BEACON PLANNING BOARD One Municipal Plaza - Courtroom BEACON, NEW YORK 12508

The Planning Board will meet on **Tuesday, February 11, 2020** in the Municipal Center Courtroom. A work session will take place at 7:00 PM for a training workshop, discussion of agenda items and/or topics of interest to the Planning Board. The regular meeting will begin immediately thereafter, but not later than 7:30 p.m.

Re: Response to John Clarke Comments dated 01/10/2020, and Lanc & Tully Comments dated 01/08/2020, 248 Beacon Holdings LLC - Fishkill Creek Development Site Plan for 248 Tioronda Avenue (Formerly Beacon 248 Development, LLC, Multifamily Development) 248 Tioronda Avenue, City of Beacon, Dutchess County, NY Chazen Project #81750.00

UTILITY PROFILES 2

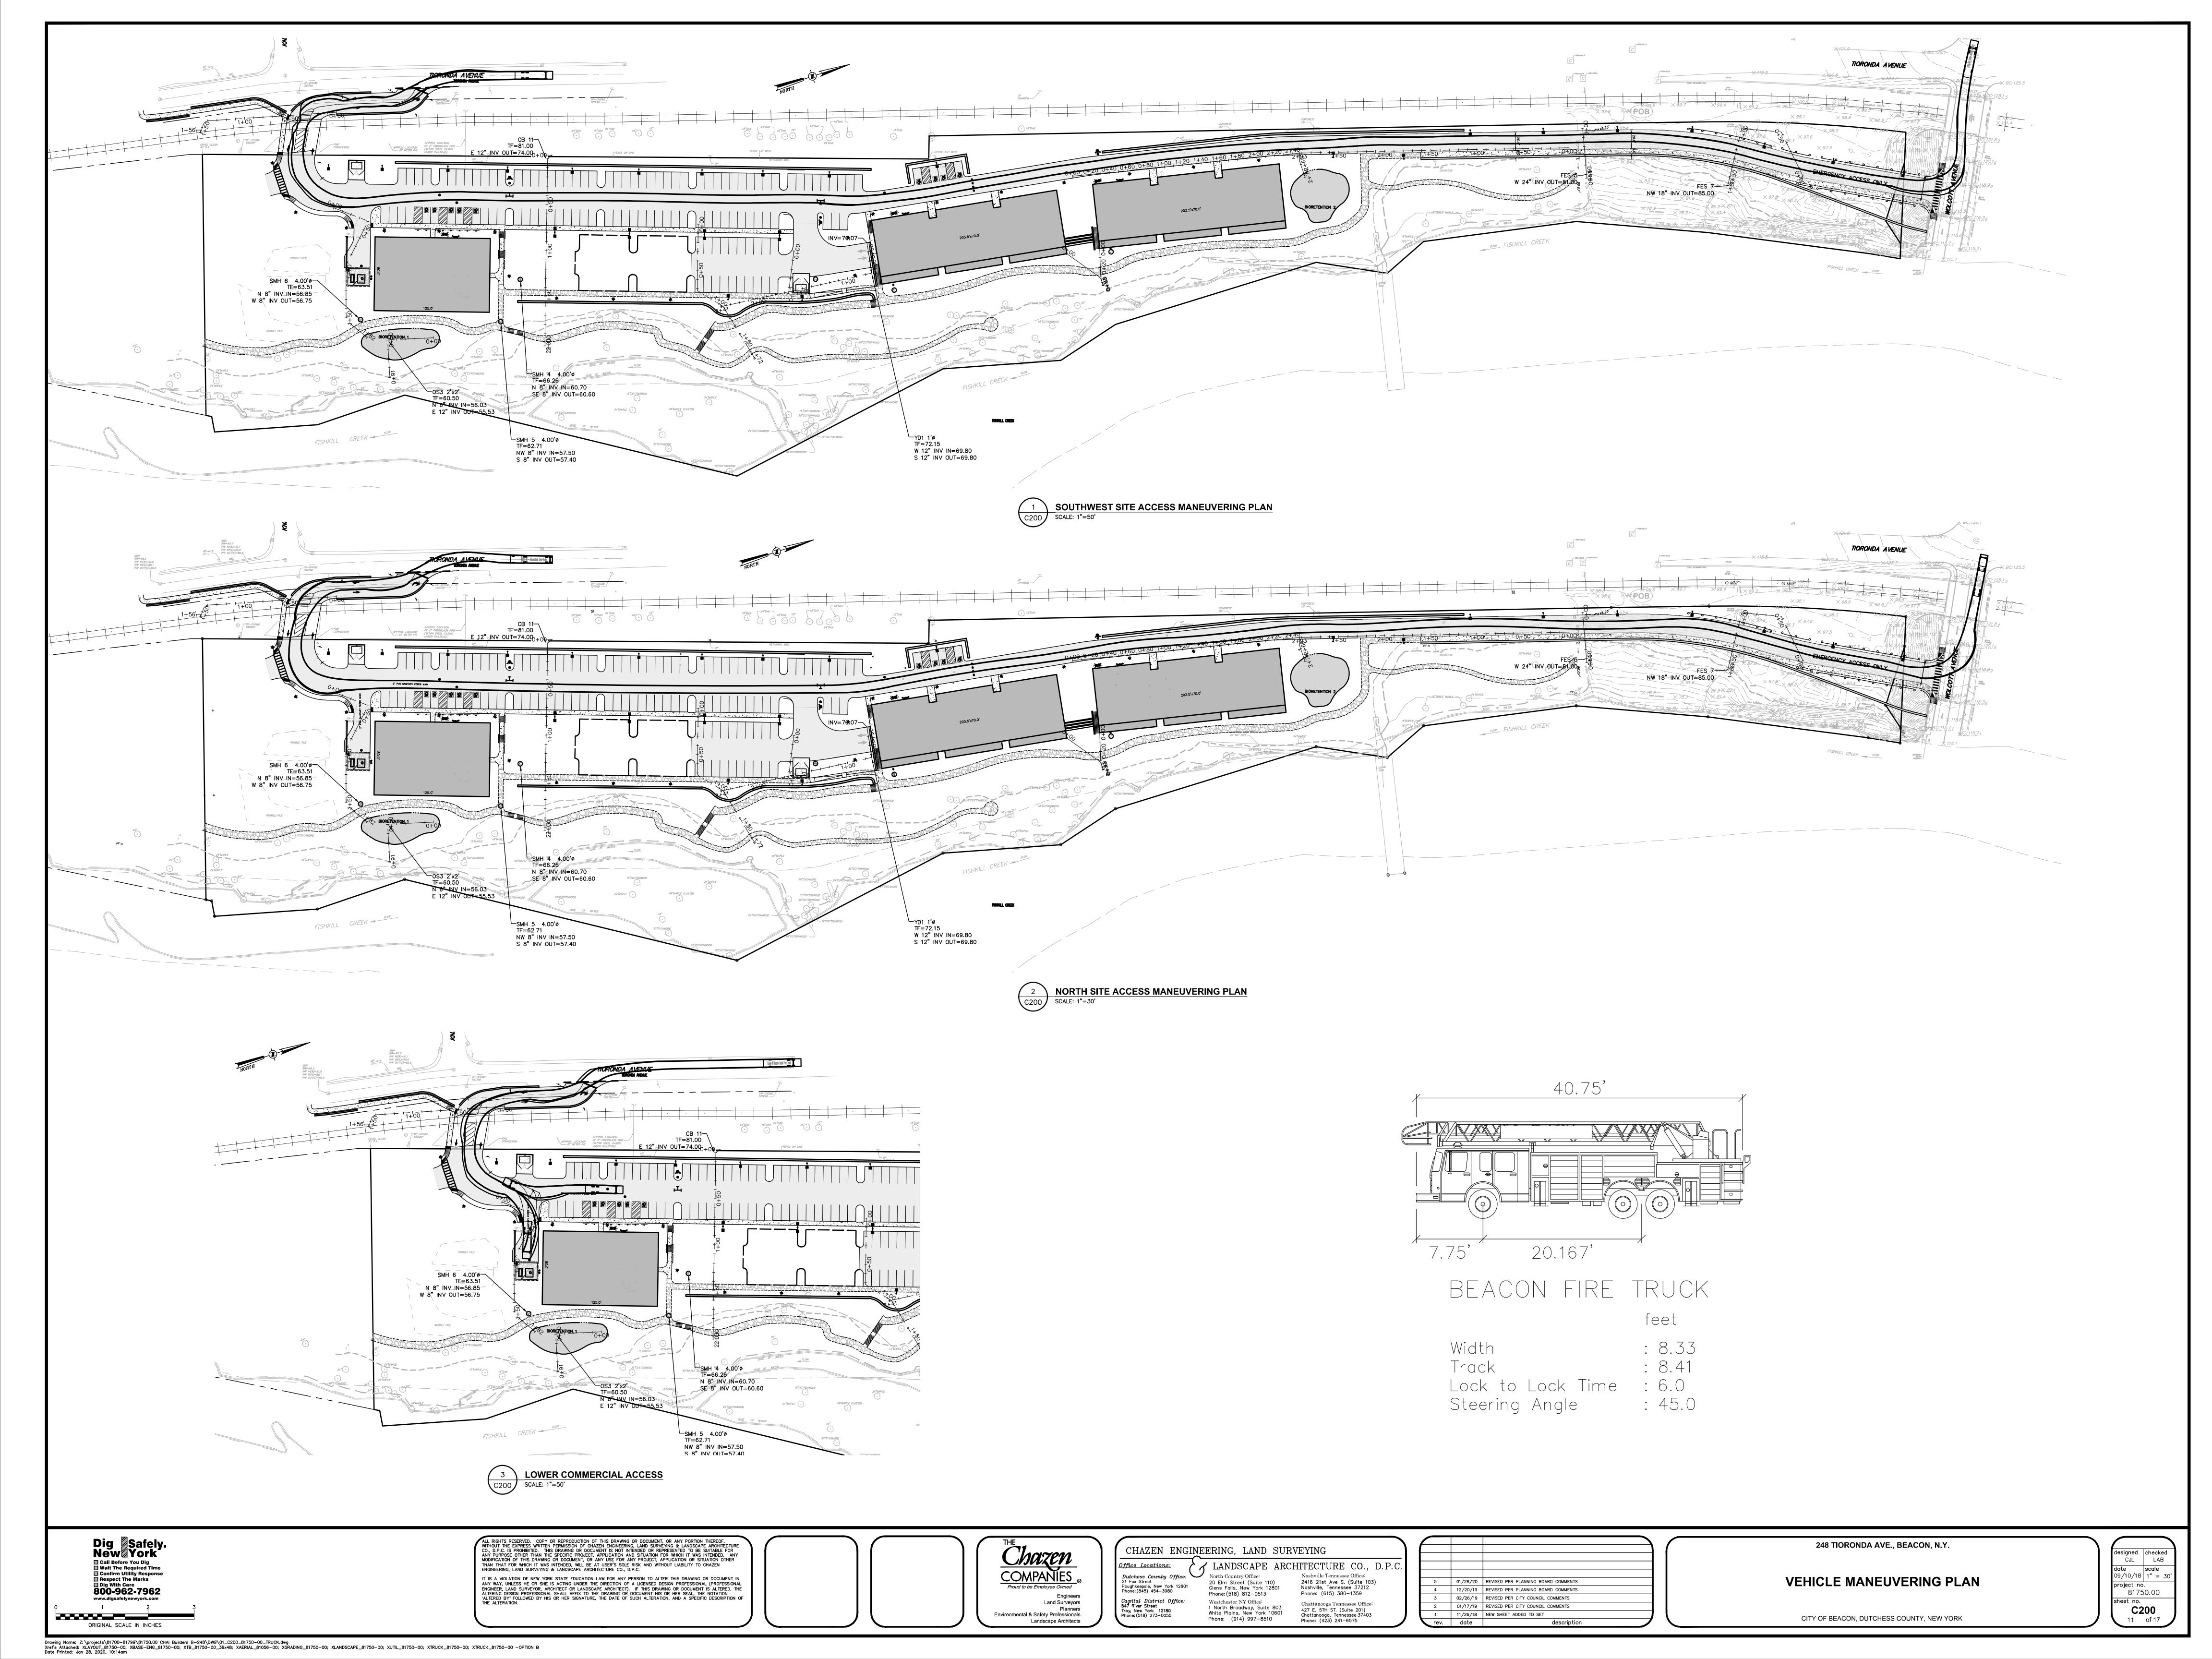
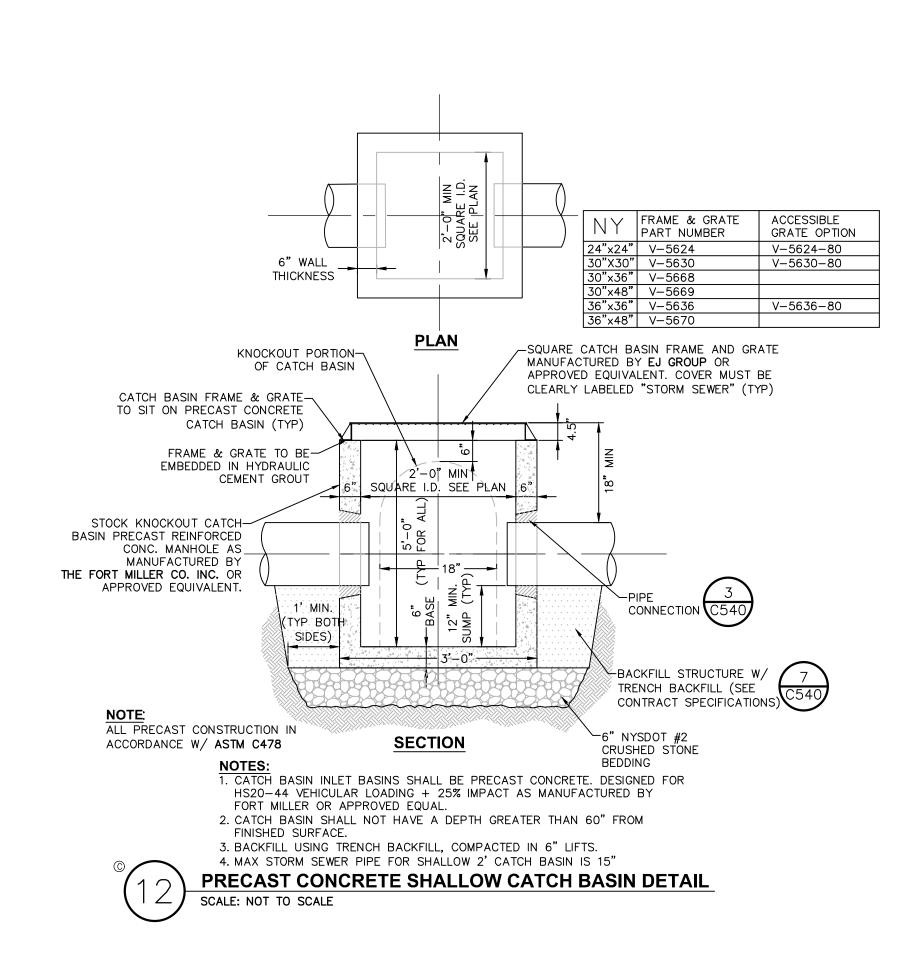
Sheet C162- Utility Profiles 2:

- 2. Several of the storm profiles have stationing labels that overlap, making it illegible. This shall be fixed accordingly.
- 3. Storm Profile 13 shows that there needs to be a vertical separation of 18" from the storm pipe to a pipe that is not labeled. The water pipe that the storm pipe is crossing should be labeled accordingly.
- 4. On Storm Profile 9, the frame elevation for CB-2 does not match the elevation that is stated on Sheet C160 Utility Plan and shall be fixed accordingly.
